**UNITED STATES DEPARTMENT OF COMMERCE**  
**Patent and Trademark Office**

# Office Action Summary

Application No.  
**09/248,057**

Applicant(s)  
**Bui et al.**

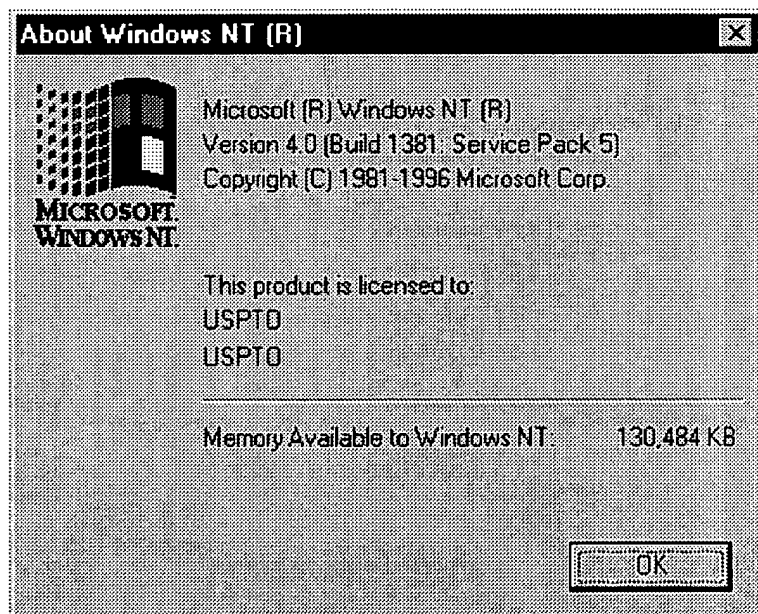
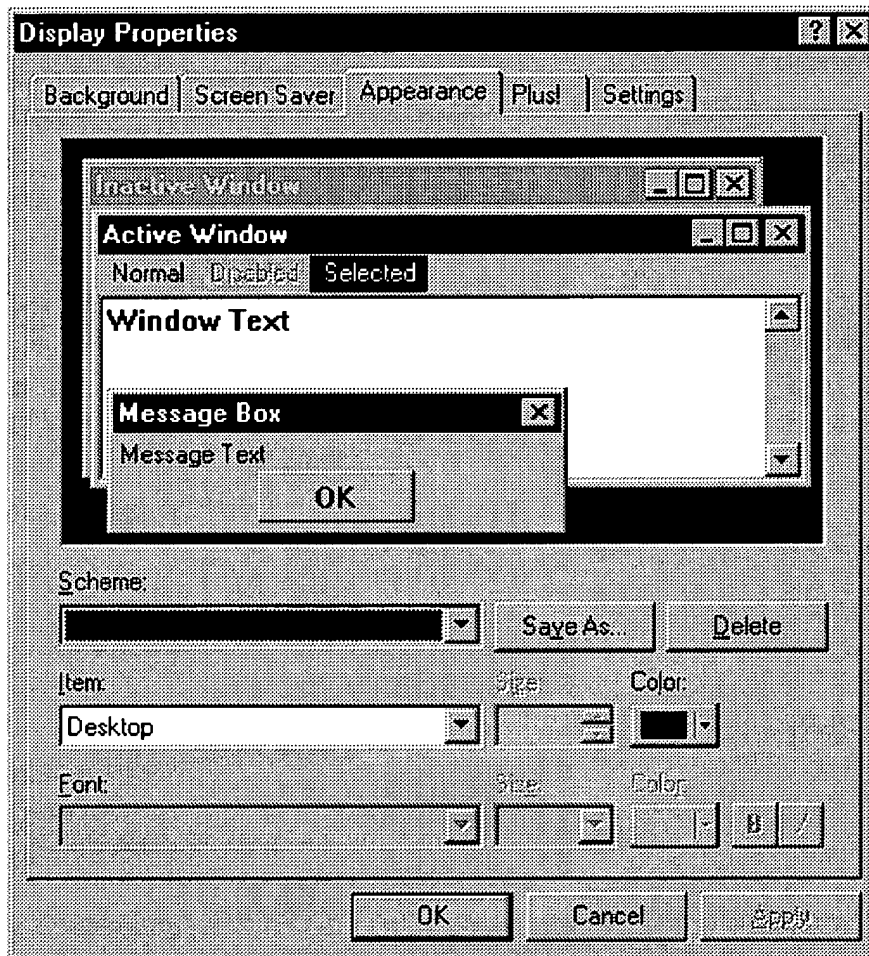
The examiner takes the position that since the device of Lynch is a computerized processing and display unit, possibly having a touch screen display, that it would have been obvious to use a well-known system of inactive keys shown in "shadow". The examiner takes the position that this system is (and has been) universally known in computer systems, and has included captured windows from his own computer showing the "Disabled" selection in "shadow", and the "About Windows NT 4.0" window that indicates that it was published in 1996.
